**Subject:** Request for Further Clarification on the Soil Amplification Issue - Clinton Power Station, Units 1 and 2

**Reference:** IPC Letter U-0533, August 26, 1982 G. E. Muller to H. Bernard, NRC

Clinton

Subject: Clinton Power Station Unit #1  
Safe Shutdown Analysis

Figure 1 - Weston Geoph. (Vanmarcke's) calculations

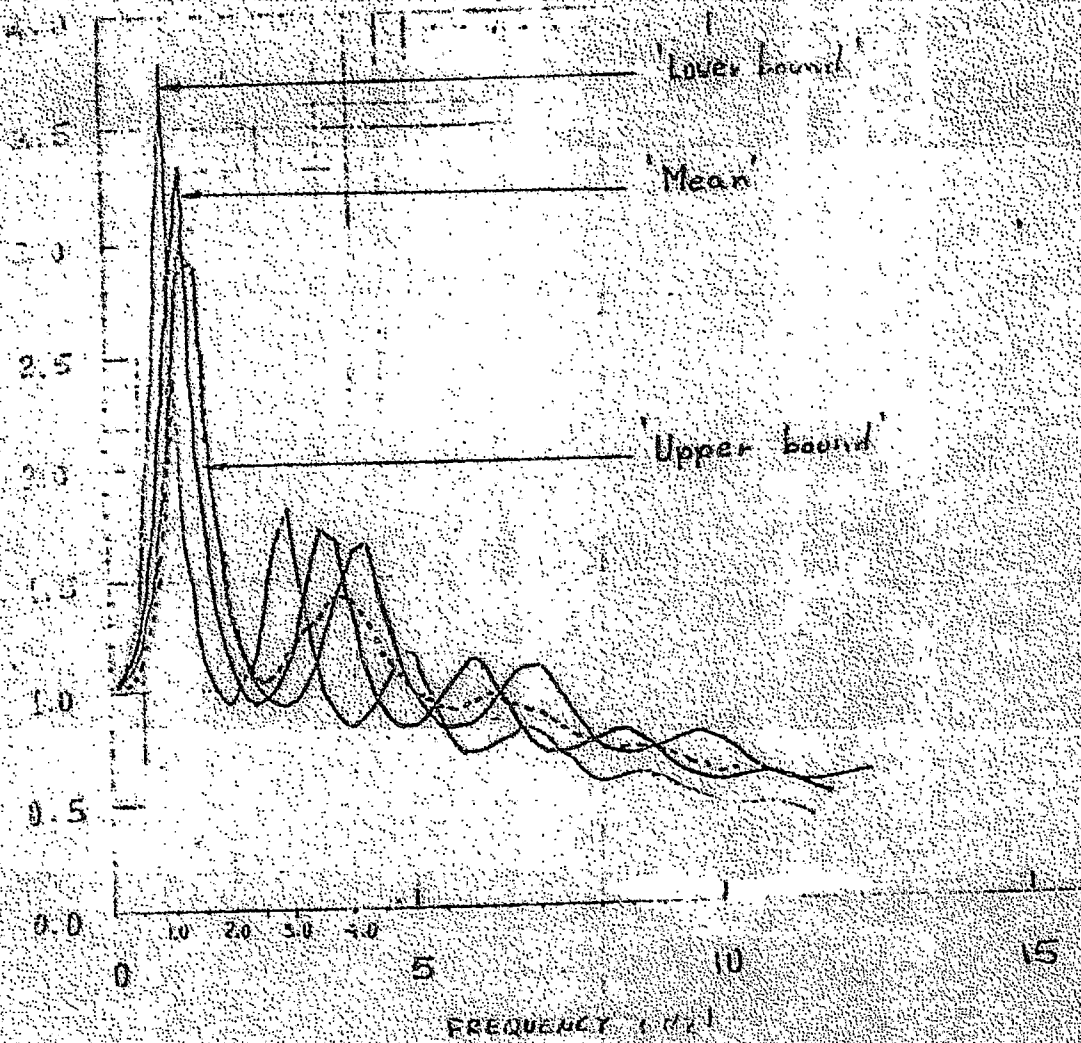
The staff has reviewed this material and has compared amplification factors obtained by using the SHAKE program (Sargent & Lundy calculations for IPC) to those factors reported in the Weston Geophysical report of May 1982, Revision 1 (Vanmarcke's calculations). Based on this review, the staff has concluded that although the SHAKE runs predict a somewhat higher amplification, there is good agreement between the predicted amplifications as a function of frequency between the two methods (Figures 1 and 2 of Enclosure 1). The annotations "upper bound" and "lower bound" in these figures pertain to the predicted range of soil properties for the Clinton site as delineated in your (IPC) letter U-0374, dated December 3, 1981, in reply to NRC's question 220.21. In your analysis, you elected to define a resultant set of amplification factors by weighting the "upper bound", "mean", and "lower bound" amplification factors by 0.25, 0.50 and 0.25 respectively. The "weighted average" amplification curve for the Weston Geophysical study is shown in Figure 1.

However, the staff has noted that the "weighted average" amplification peaks are considerably lower than the peaks on the "mean soil property" amplification curve (Figure 1). In the case of the amplification factors obtained from the SHAKE program, the "weighted average" peaks fall outside (below) the range of peaks predicted by the range of soil properties (upper/lower bound) assumed for the site (Figure 2). In past safety reviews the NRC has recommended a conservative approach of enveloping the effects of soil amplification if uncertainties existed.

Therefore, we request that you discuss the resulting fluctuations in the theoretical soil design response spectrum caused by assuming a range of soil properties. Subsequently you should justify, statistically or otherwise, the use of the weighting procedure referred to earlier in this letter in light of past NRC positions. Any questions concerning this information request should be directed to Dr. Harvey Abelson, the Clinton Project Manager, at (301) 492-9774.

FIGURE 3 - "WEIGHTED AVERAGE" FOR CLINTON SOIL PROPERTIES

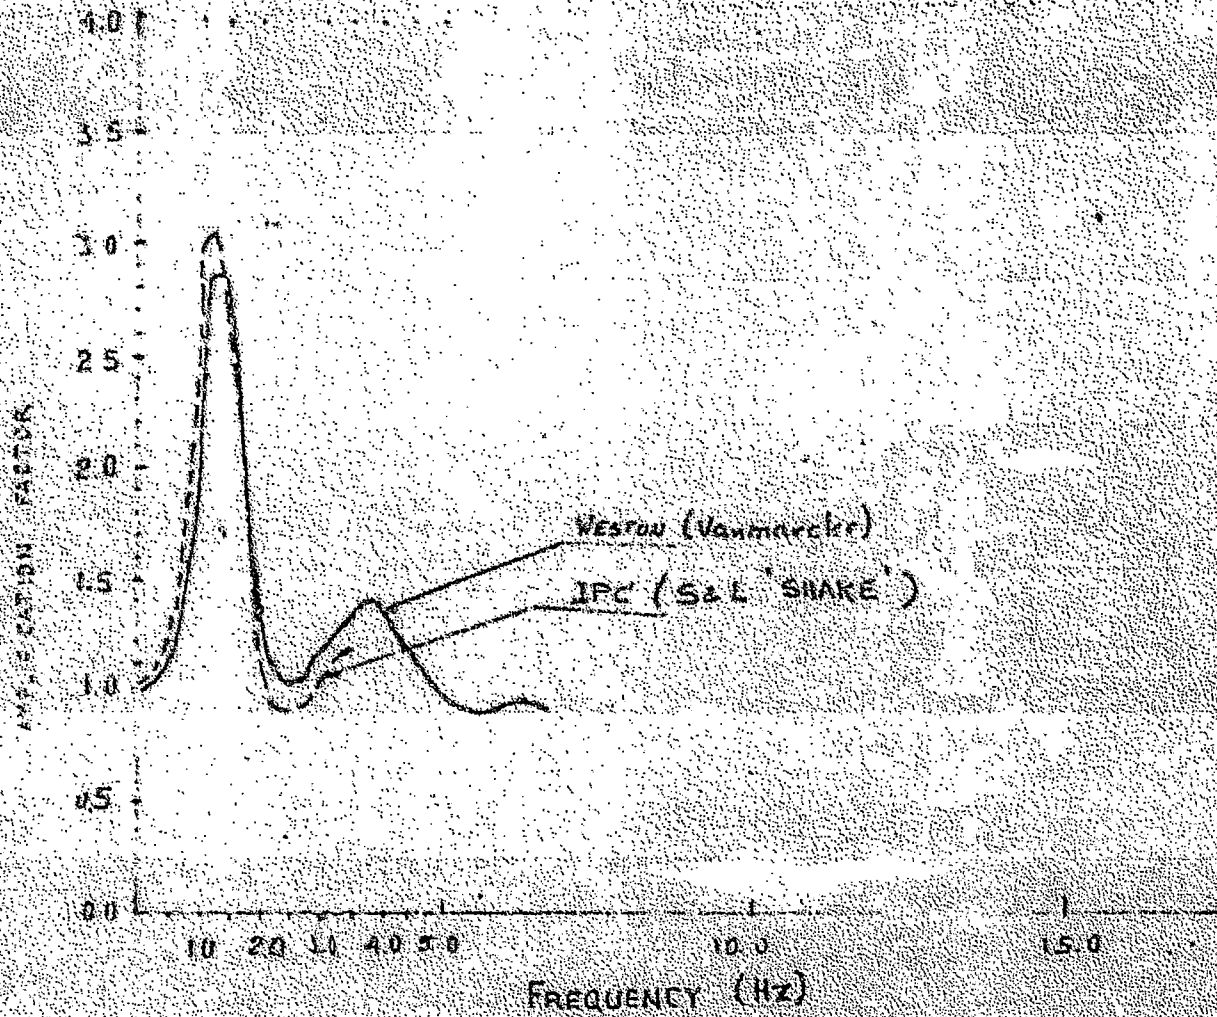
The staff has constructed a similar curve for the amplification factor curves obtained by using the SHAKE Program and the results show that the differences between the "weighted average" obtained by Sargent & Lundy (SHAKE) and Weston Geophysical (Vanmarcke) are negligible (Figure 3 of Enclosure 1).
